Access Compliance Report Public Rights-of-Way (Curb Ramps)

Main Street: MARQUIS_CIR Cross Street: CASTLEGATE_LN Location: SE

ADA ID: RPRK211011110257 Ramp Type: Type 1 - Perpendicular Diagonal Initial Pass/Fail: Pass Overall Compliance: No Severity Score: 10

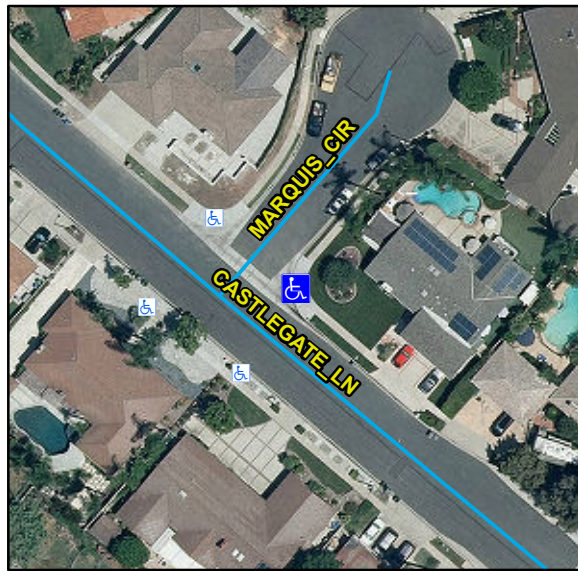
R304.2.2, R304.2.1, R304.2.2-Perp, R304.3.2-Para, R304.5.3, STD 1115

Remove & Replace Curb Ramp With Two New Directional Ramps or Equivalent.
